CITY OF TAYLOR, TEXAS

PLANNING AND ZONING COMMISSION MEETING

December 13, 2022, 6:00 P.M.

**MINUTES
CITY OF TAYLOR, TEXAS
400 Porter Street
Taylor, Texas 76574
PLANNING AND ZONING COMMISSION MEETING
November 8, 2022, 6:00 P.M.**

- LEGEND**
- IRON ROD FOUND
 - IRON ROD SET
 - ⊕ BENCHMARK

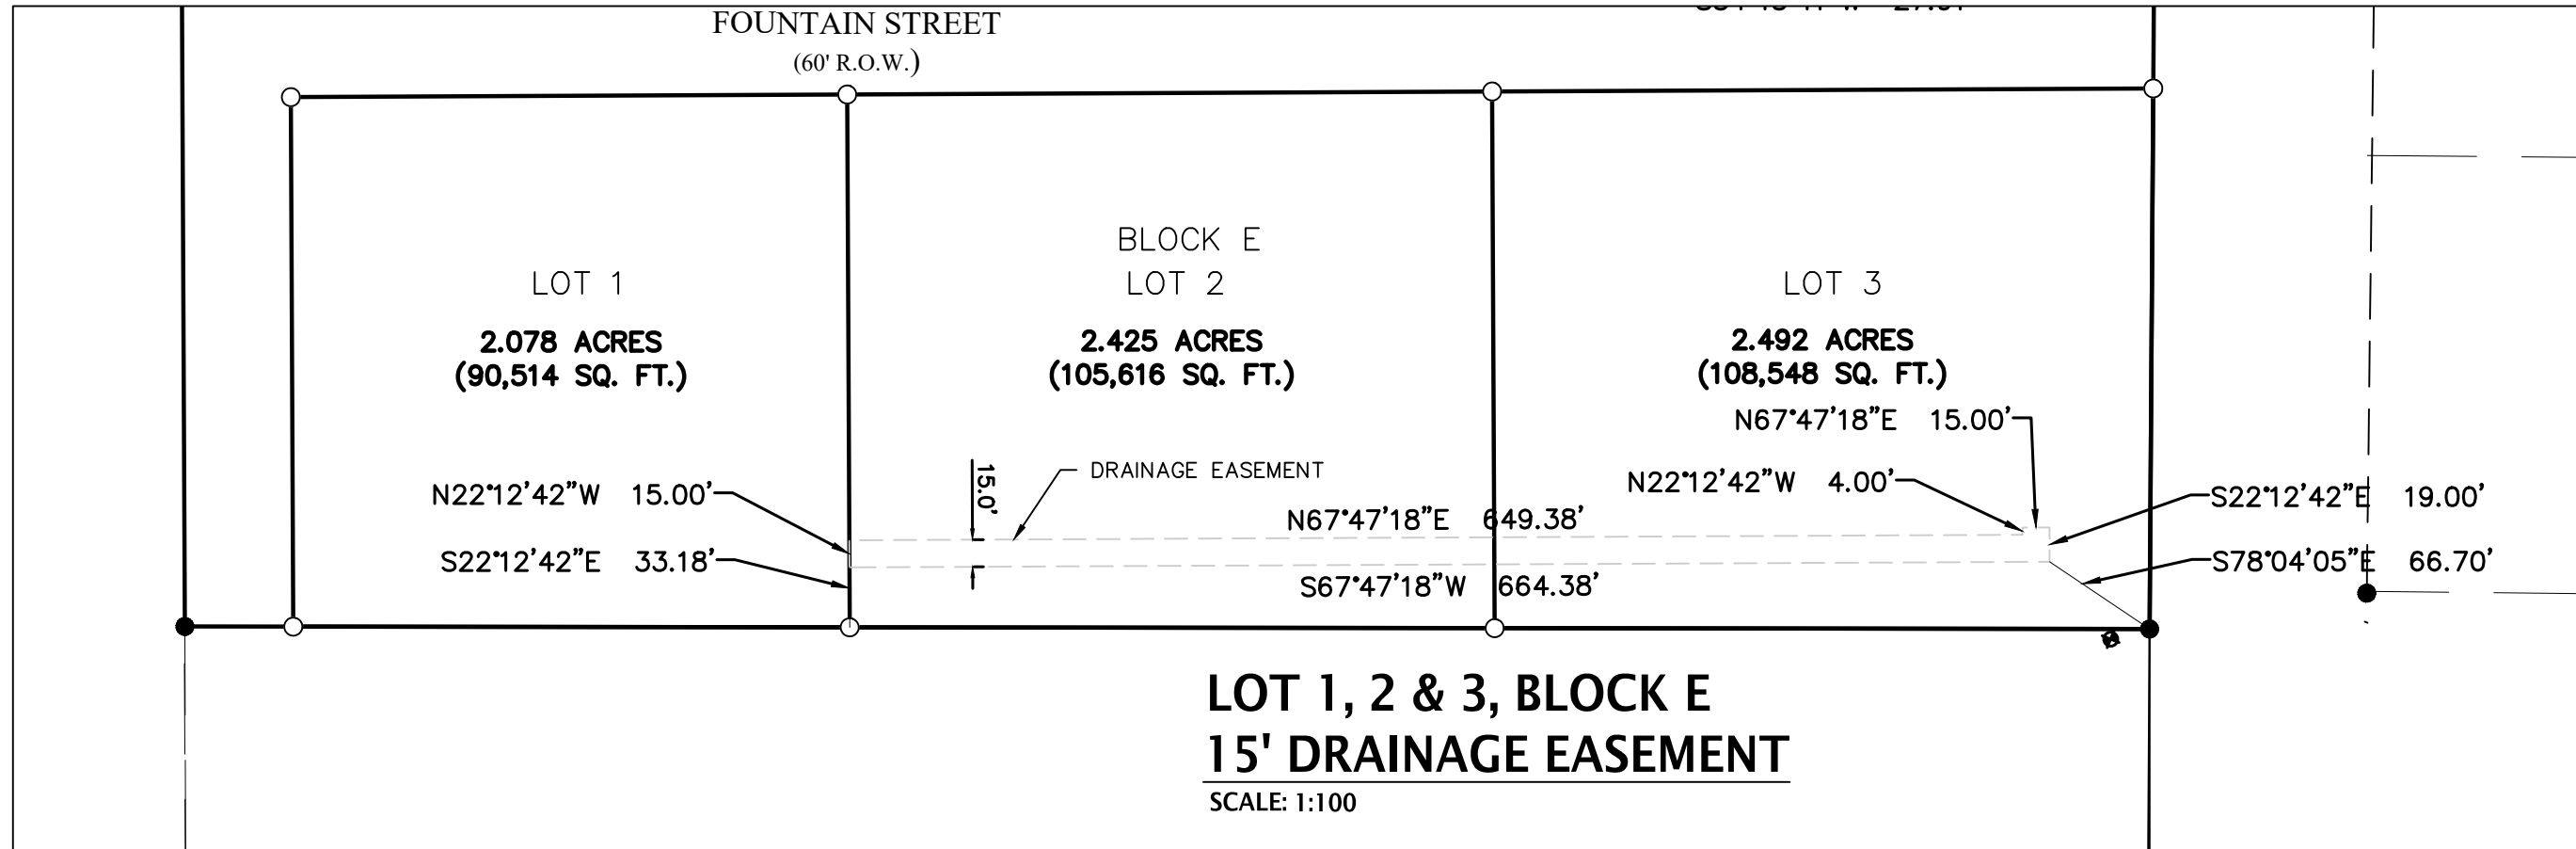
1. All lots must show a 10.0' public utility easement along street frontages. A plat note will not meet this requirement. Moving electrical utilities into the right-of-way has not been historically granted. The applicant should confer with the electric utility provider (ONCOR) to request that their utilities be placed within the right-of-way.

3. A private wastewater line and easement within Block E, Lots 2 and 3 is not standard and not recommended. Wastewater connections should be off the proposed wastewater line along Fountain Street (public right-of-way). Additionally, the schematics for said proposed private water easement etc. should not be part of the preliminary plat. It is understood that this was to provide further detail but pages 2, 3, and 4 should be removed and captured within future steps of development.

1. Update plat to place the proposed detention area outside of the proposed 20-ft P.U.E. along North Main Street.
2. Revise plat to remove proposed "Private Wastewater Easements". Coordination shall be made to coordinate utility schematic for this area.
3. Verify and provide curve table on the plat. The curve table was removed in this submittal.
4. The plat shall reflect how the existing water easement at the northwest corner will be abandoned with this plat.
5. Show 10-ft PUE along all street frontages (TYPICAL).

1. The width of the fire department access road shall be noted.
2. The schematic of the proposed utility plan shall indicate the fire hydrants and the distances between the hydrants that shall be no greater than 500 feet apart.

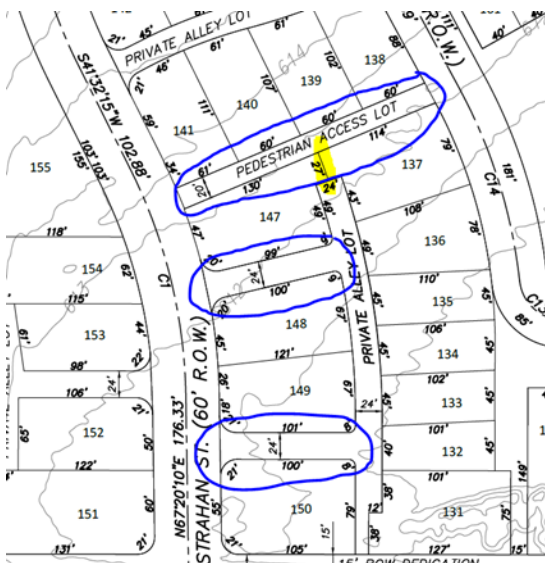
14. The configuration of lots 55 and 56 is odd and will be difficult to site a building on.
15. Consider eliminating the alley between lots 184 and 185. Also consider a pedestrian path between lots 178 and 186 connecting to the alley.

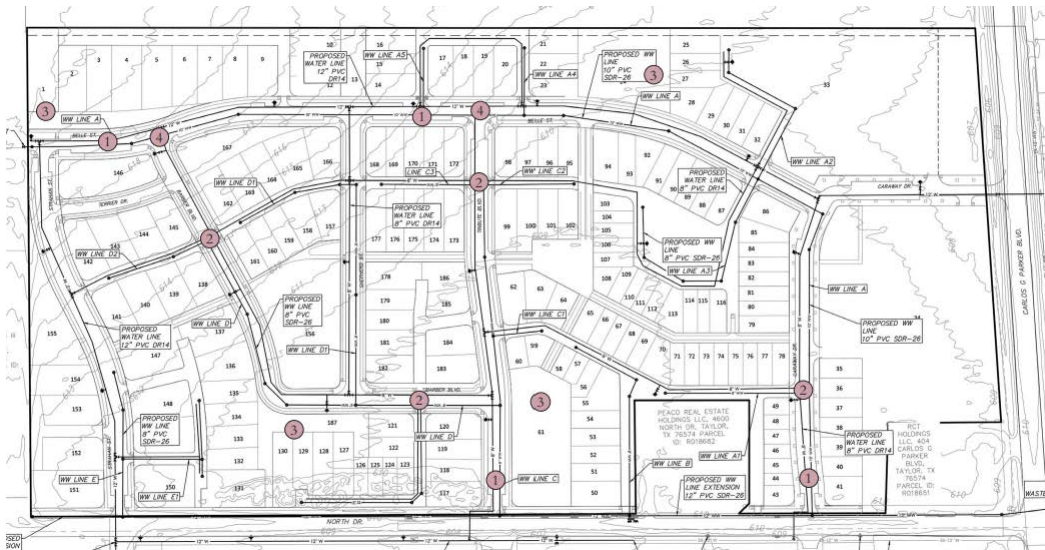
1. Lots should be shaped to allow the front facade of the primary building to be parallel to the front property line. See below a sketch of one potential solution:
